Addendum #	02	Date Issued	03/31/2025
Project Name Job #	SWN 0509, Waneta Hall Renovate Restrooms	OSE # R0325--15X	EAPC #20256780
Bid Date Time	April 3, 2025		3:30pm

THIS ADDENDUM AMENDS AND BECOMES PART OF THE CONTRACT DOCUMENTS FOR EAPC PROJECT 20246780 DATED 03/13/2025, RESPECTIVELY. EACH BIDDER SHALL ACKNOWLEDGE RECEIPT OF THIS ADDENDUM BY MARKING THE ADDENDUM NUMBER AND DATE ON THE BID FORM.

DRAWING TITLE
LIGHTING PLAN - ADD ALTERNATIVES

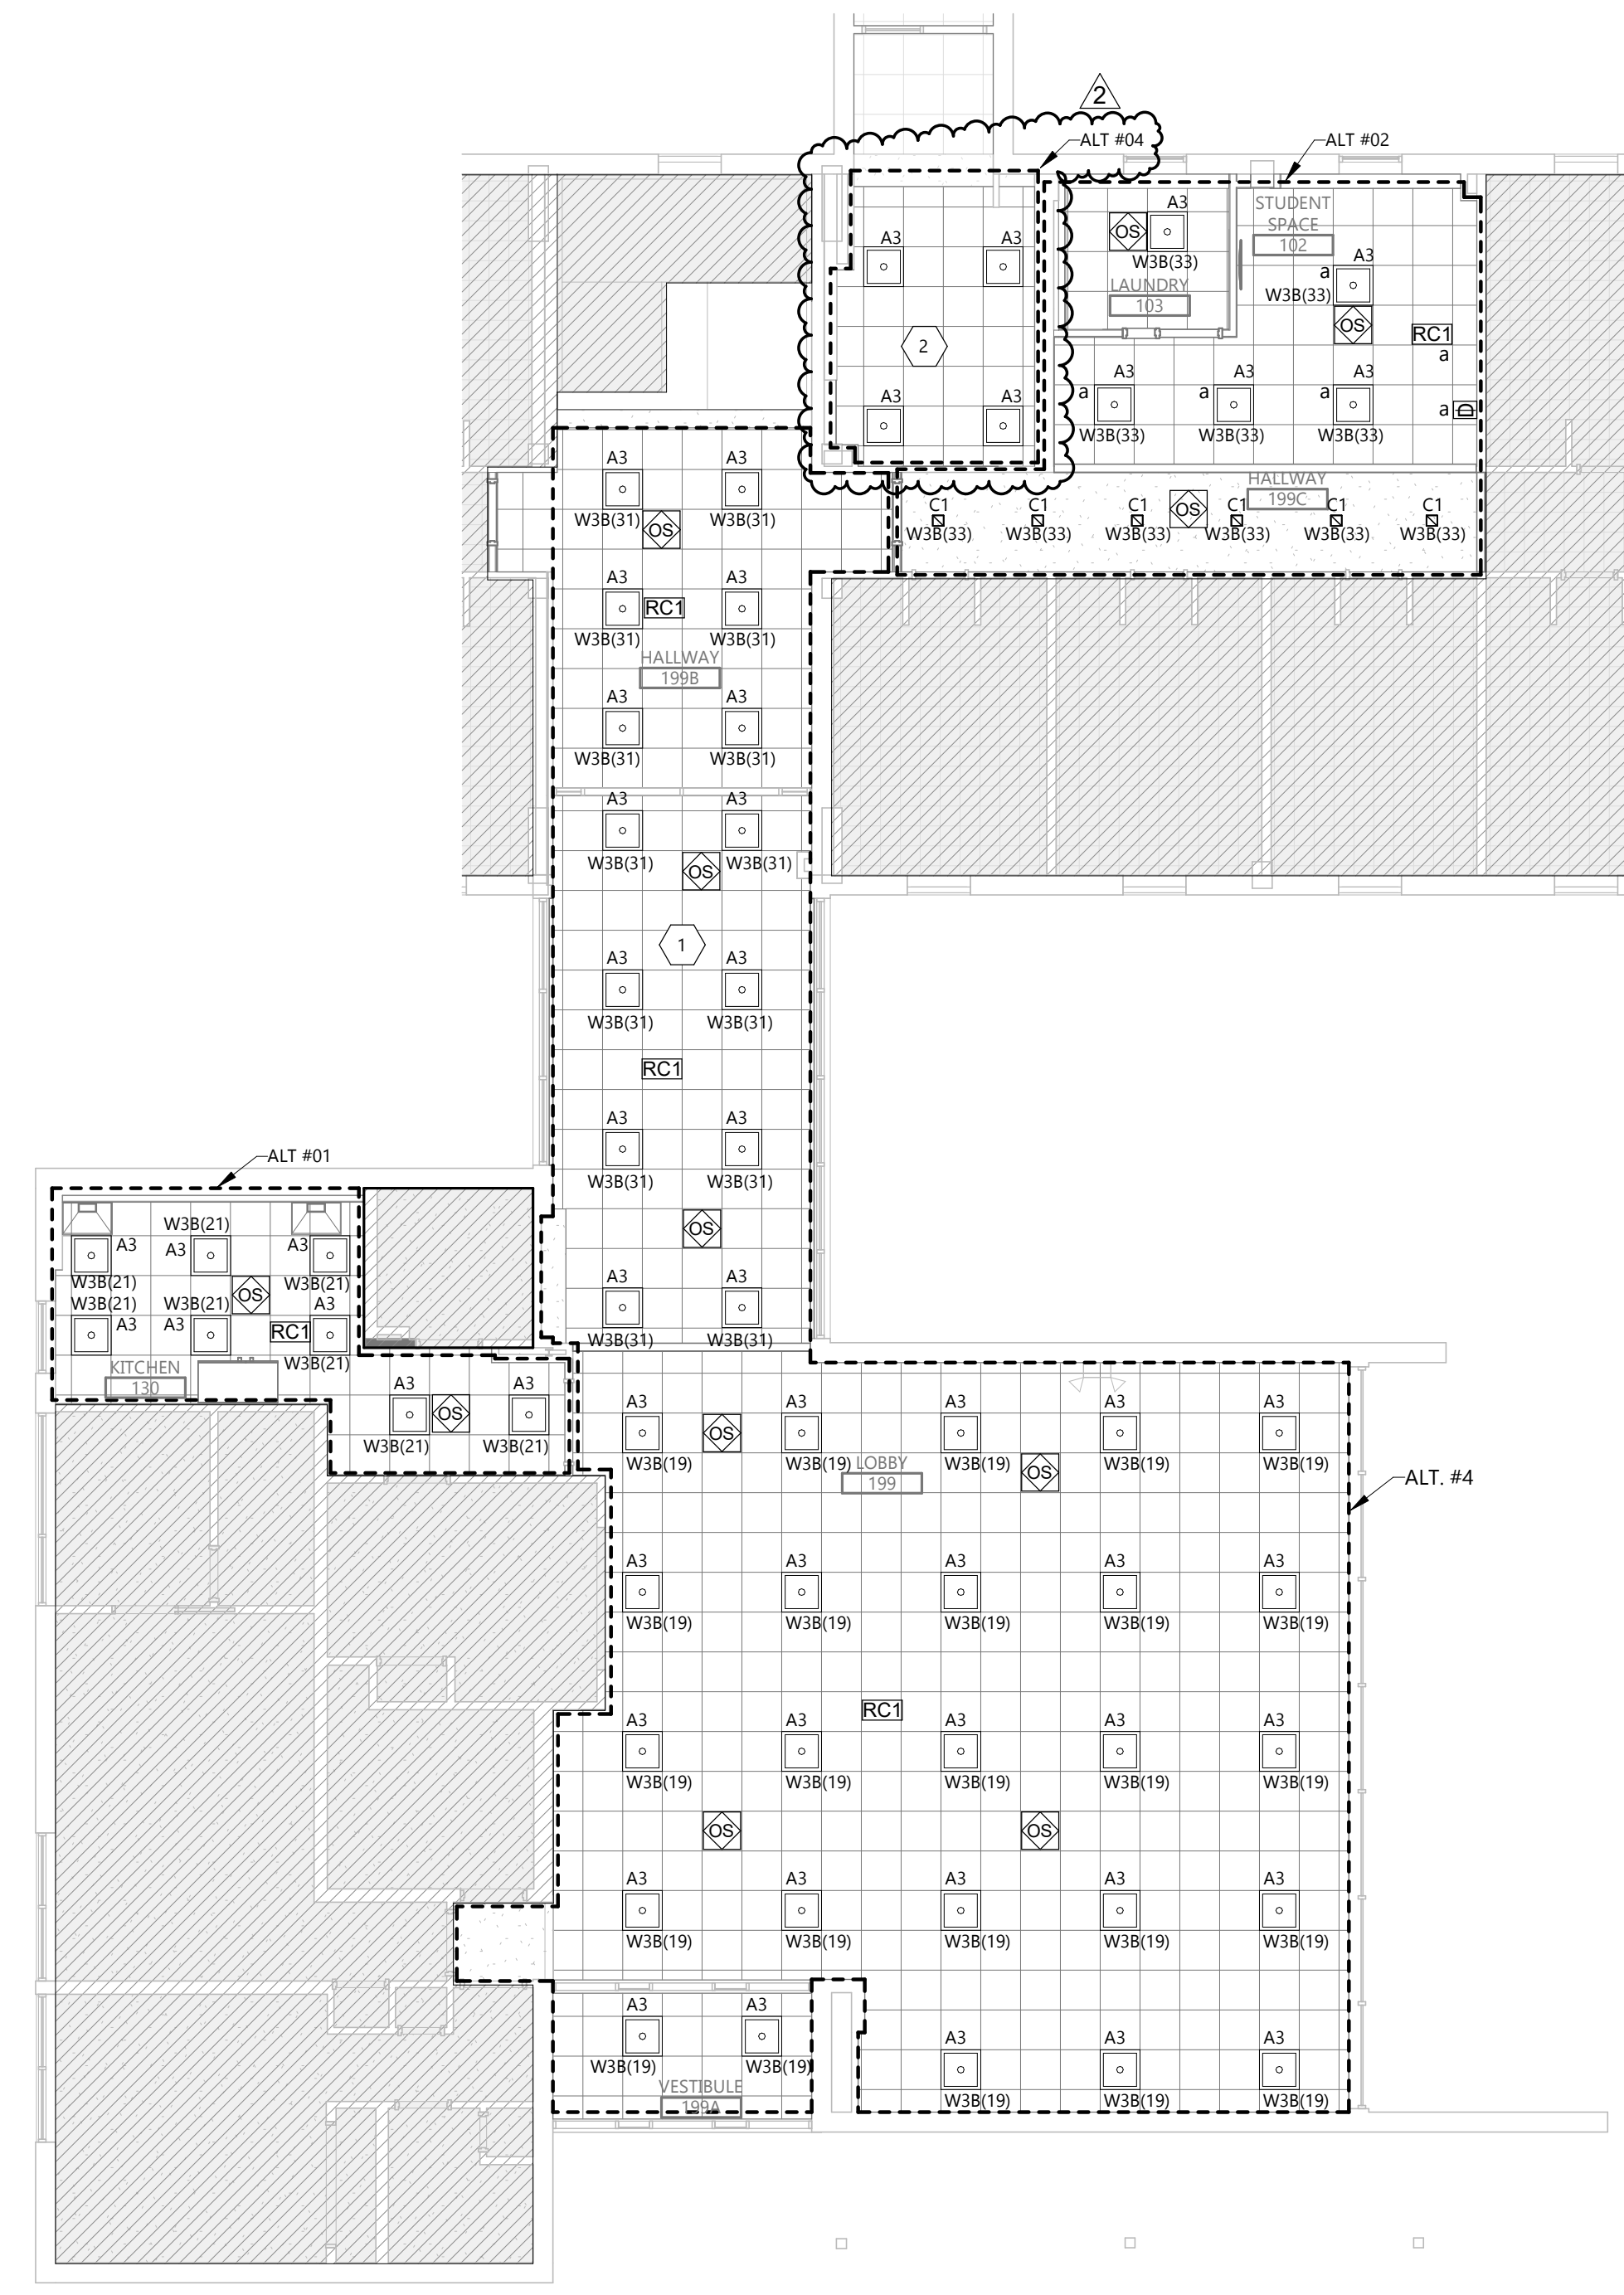
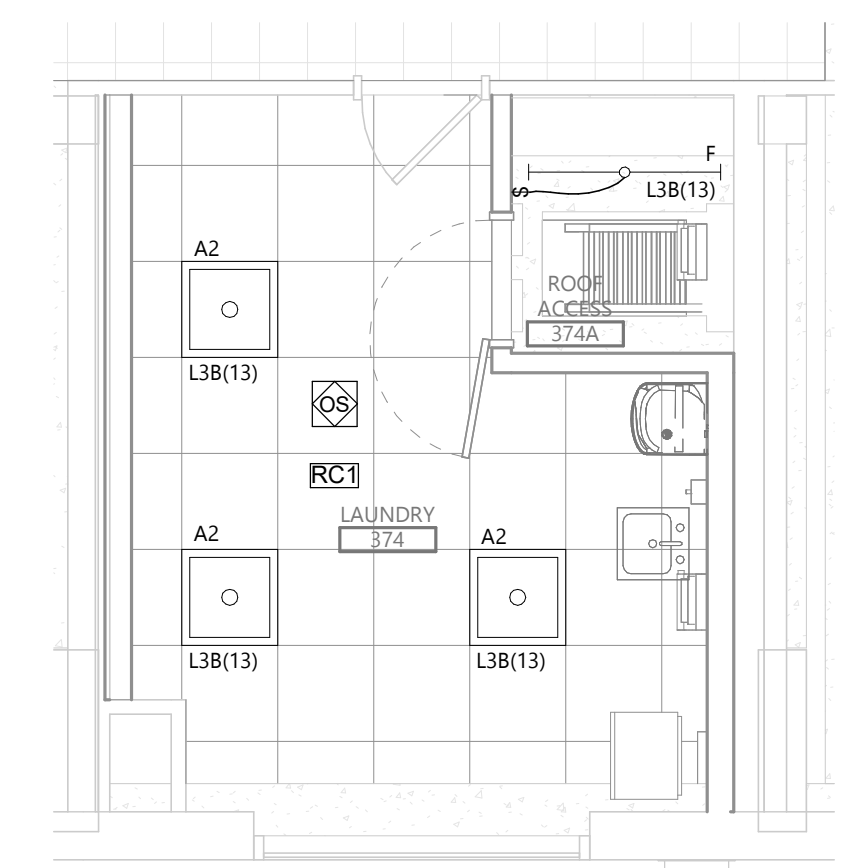
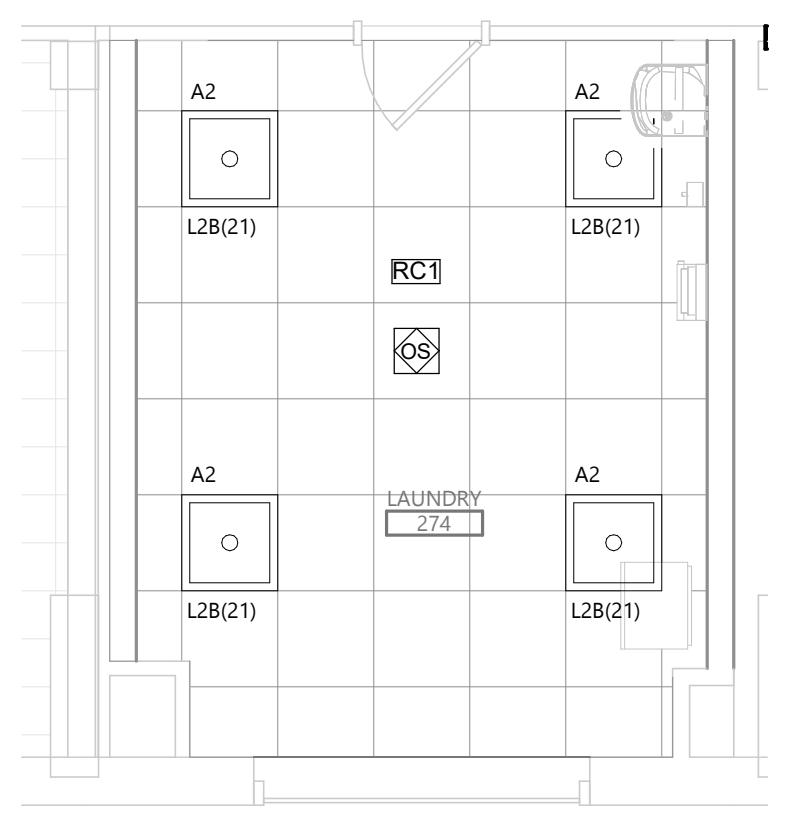
E203	Note 5 added for clarification on relocated data panel.
E304	Add A3 fixture and connect to circuit W3B(31).
E802	Provide six (6) extra C1 lights for Owner attic stock. Add V1 fixture.
